City Council

November 18, 2025
Packet Addendum #2
11B_Coal Creek Village Public Comment

Major Issues with Coal Creek Development Plan

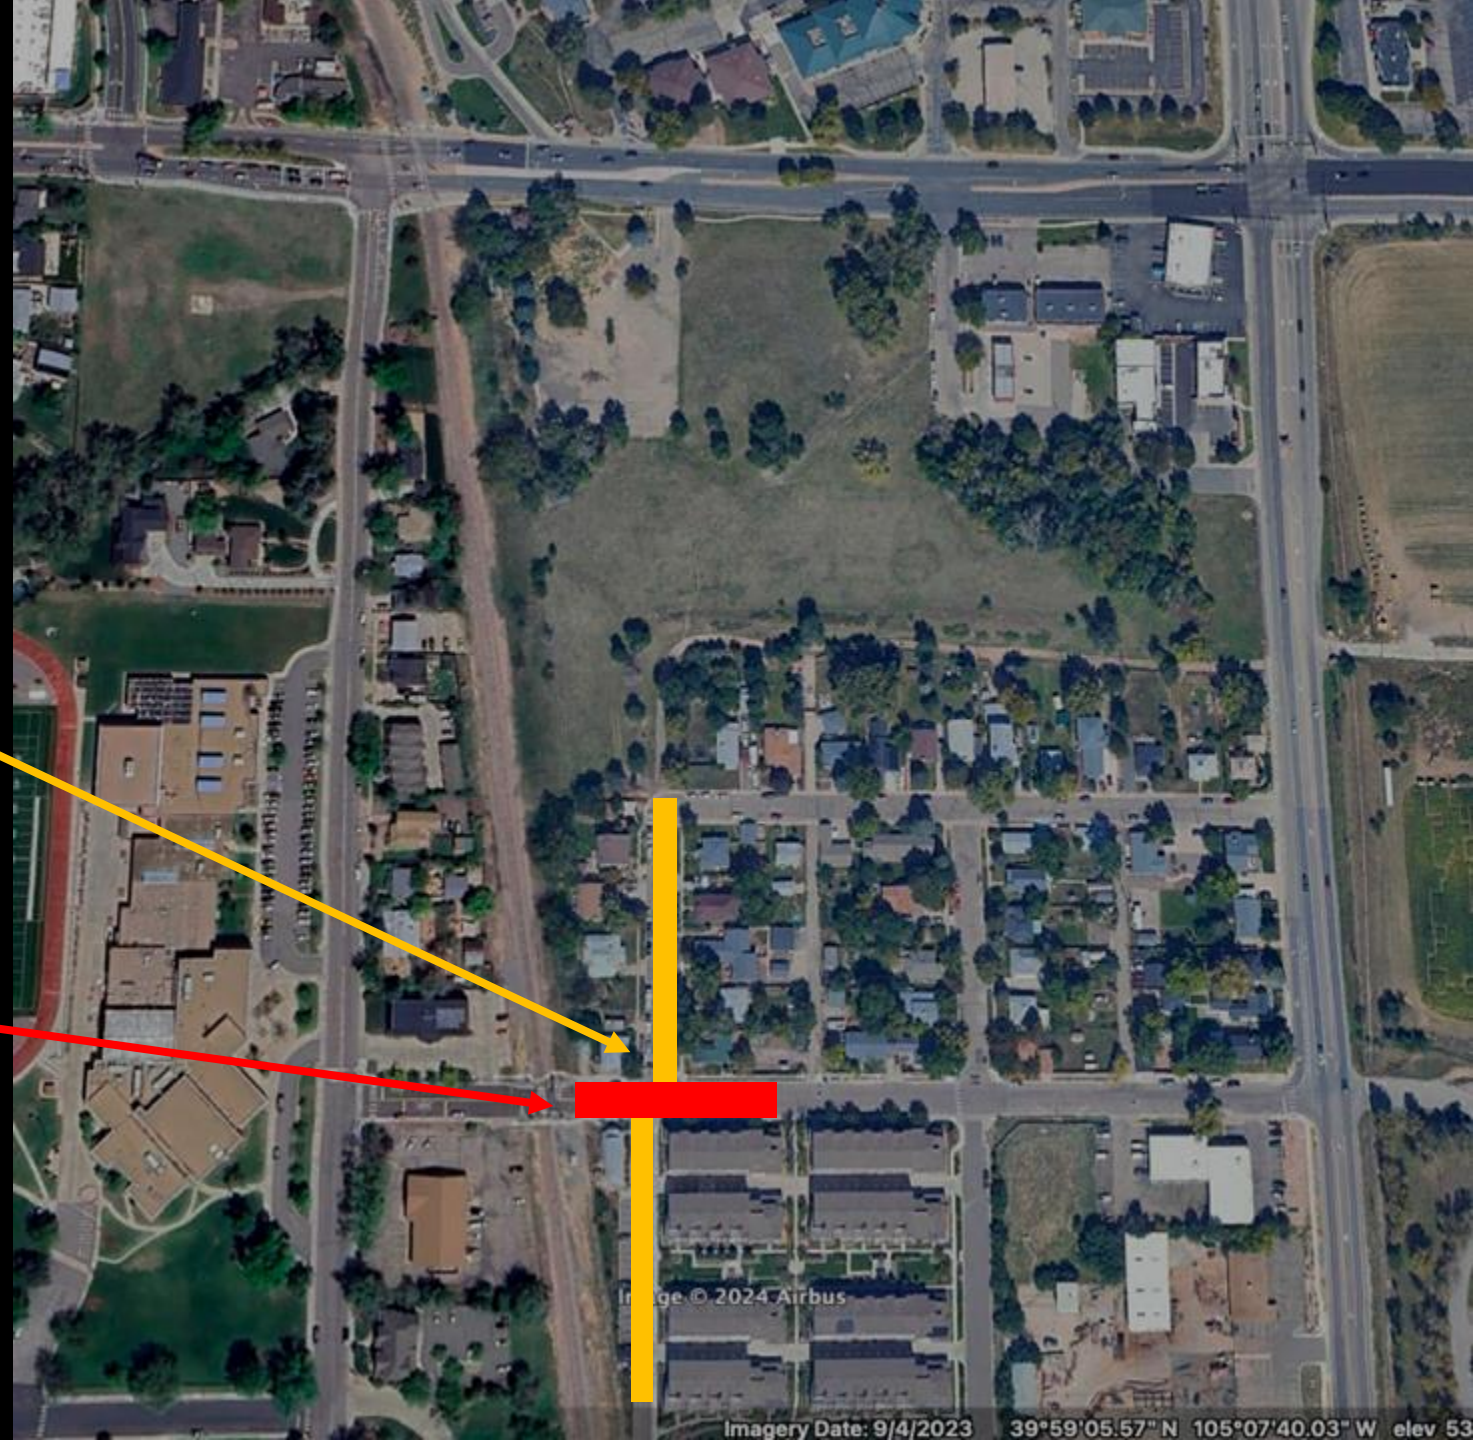
- Front St. cannot continue because of Delo development, offset and leads to parking lot for Delo
- Only takes 2-4 cars to block intersection at train crossing (already a problematic intersection for small neighborhood residents)

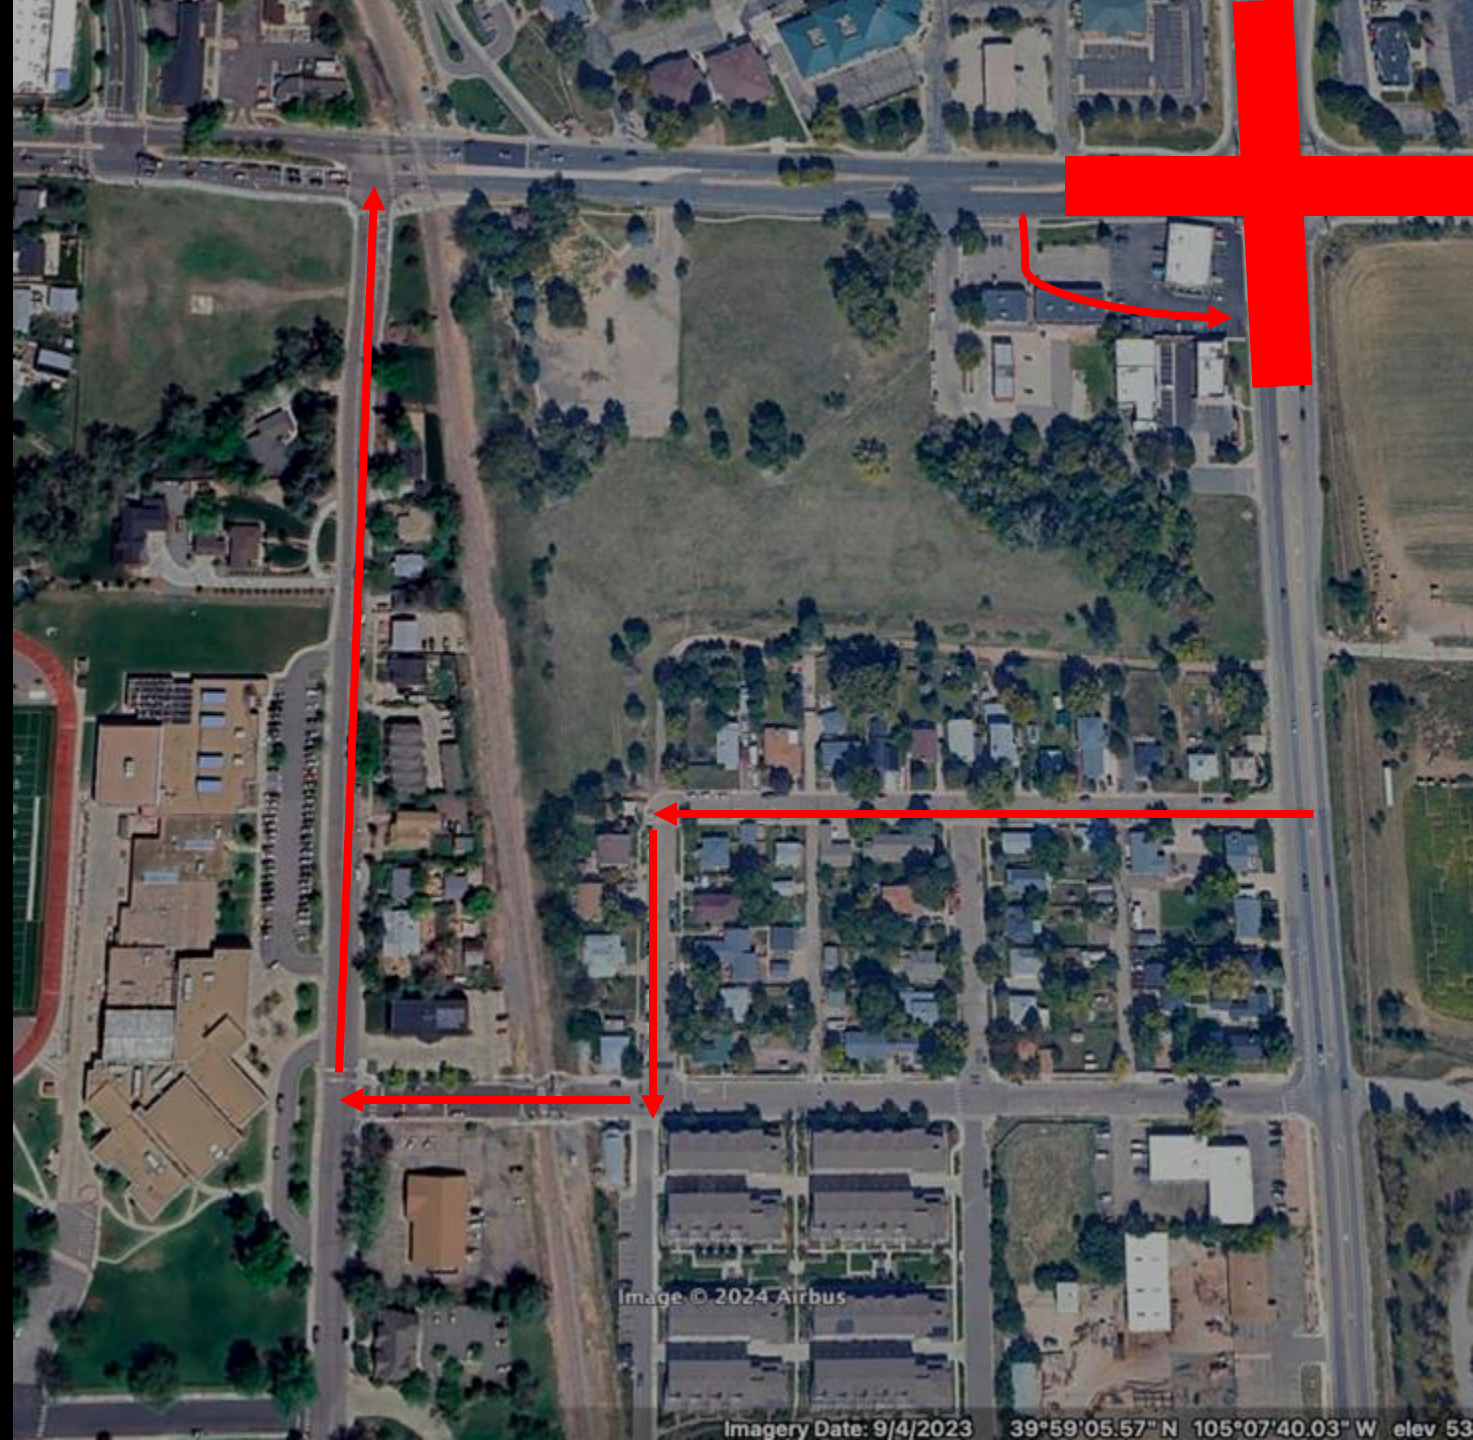
- Failing intersection at S. Boulder Rd. and 42
- There are already problems with cut-through traffic and increasing safety issues at Louisville Middle School

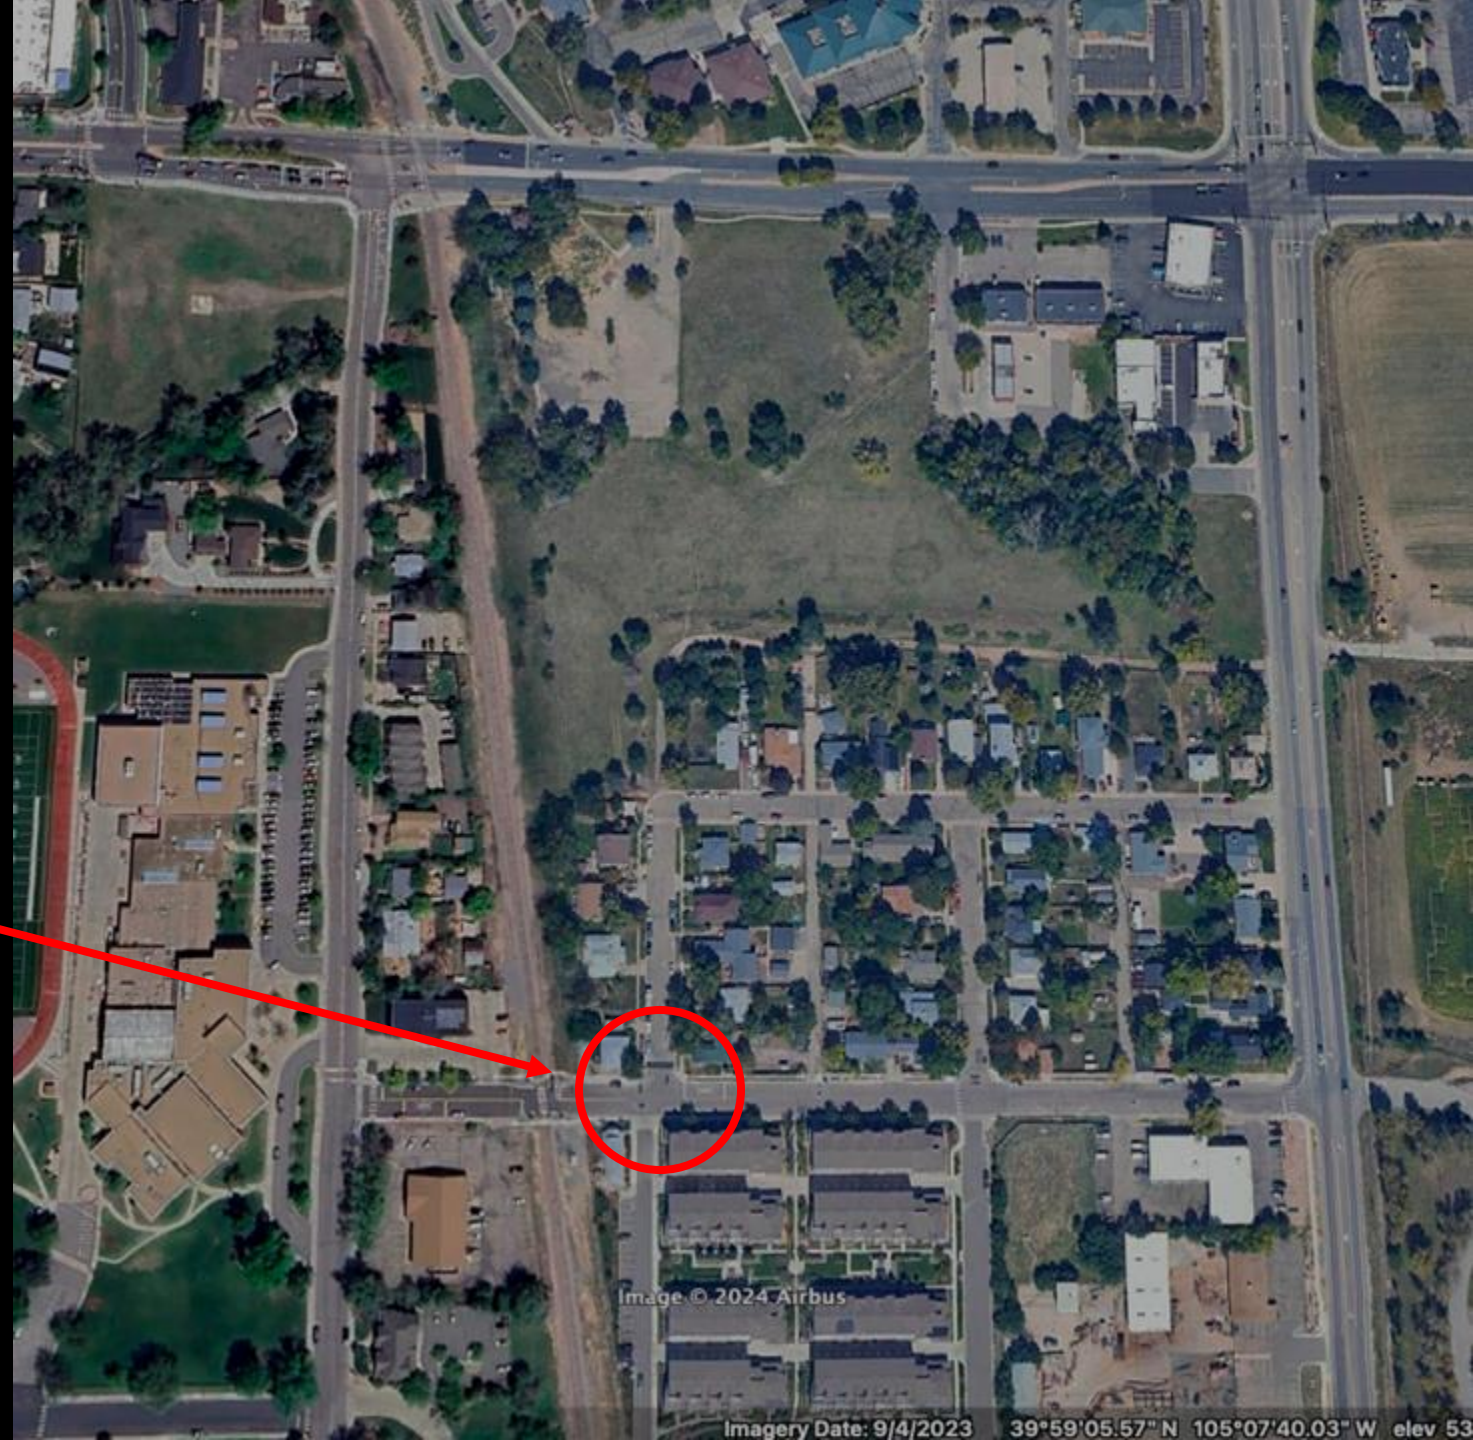
- Front St. and Griffith St. (clog point, railroad crossing, and major safety + traffic problem) not included in traffic study.
- Recent city investment in quieter train crossings did not anticipate routing thousands more cars/day through intersection.

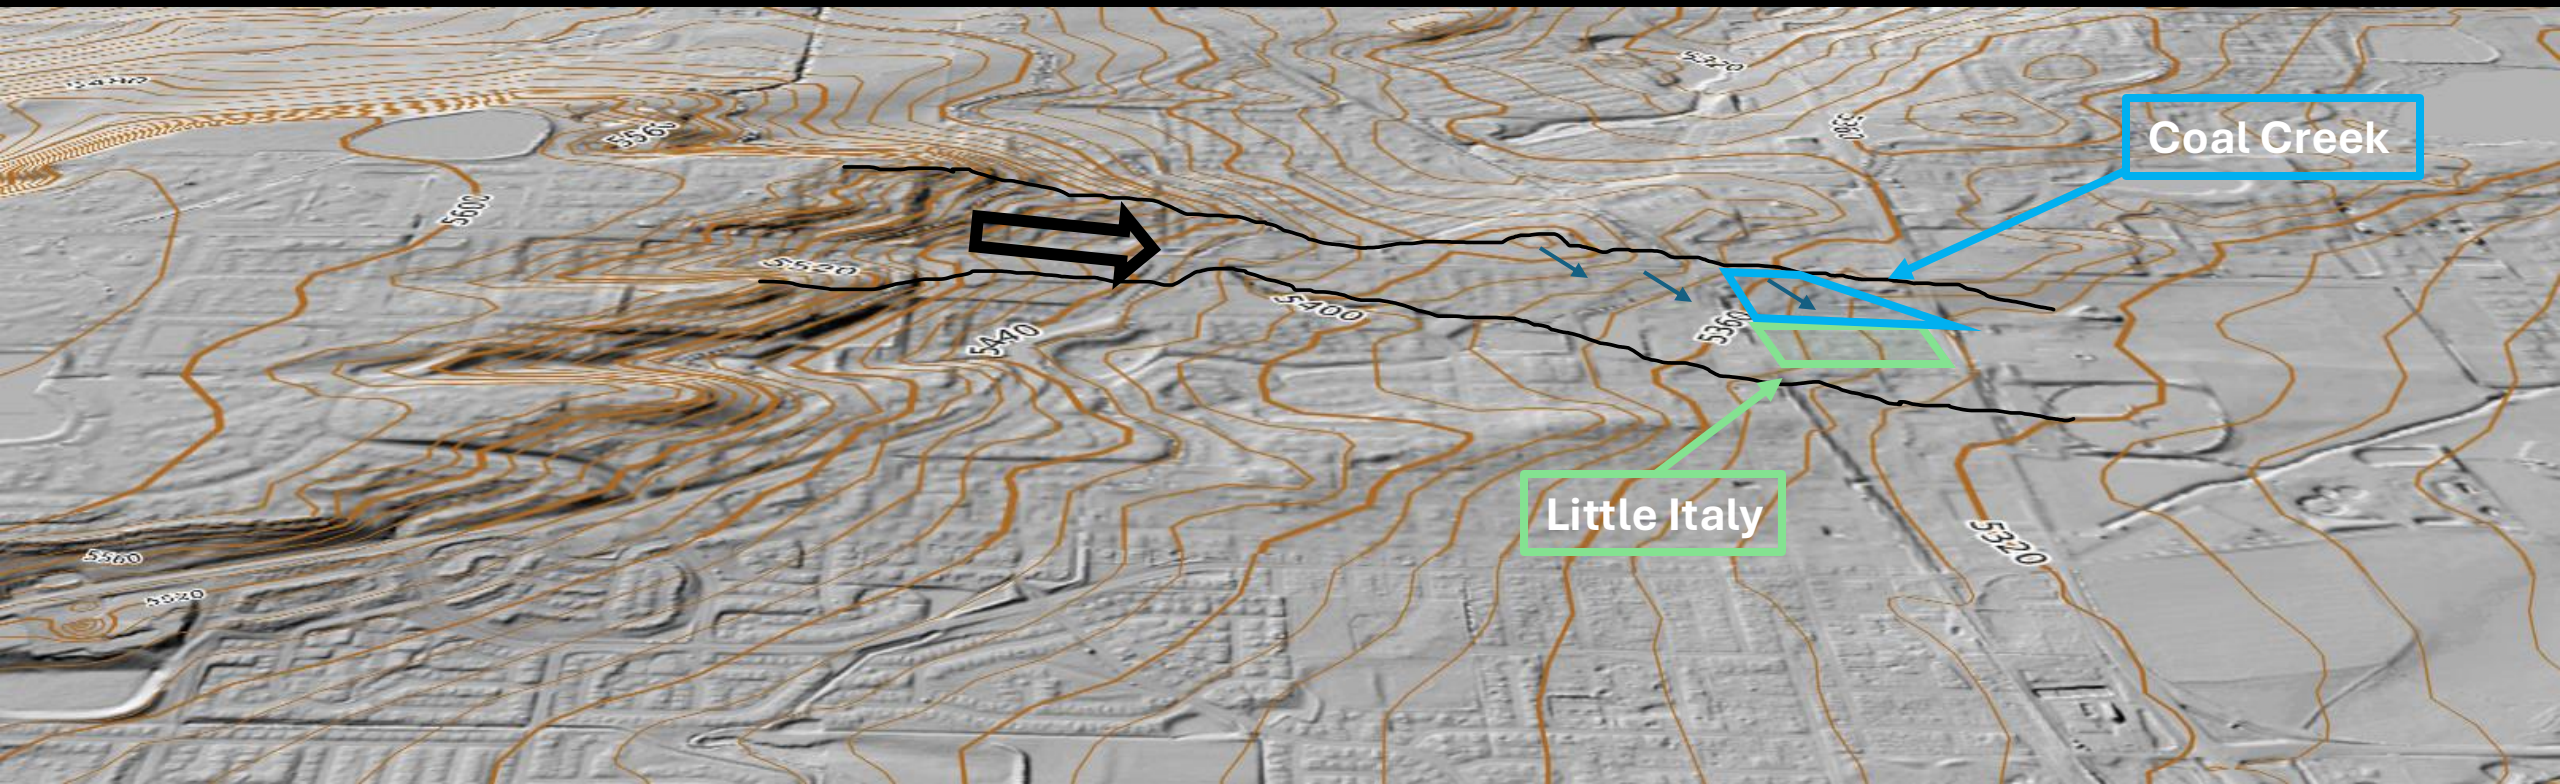
- PUD proposes routing all water TOWARDS Little Italy into underground storage, if these fail, historic houses built on cobbles/cinderblocks will be risked.
- Developer was unwilling to share flood engineering drawings with Little Italy residents in advance of this meeting.
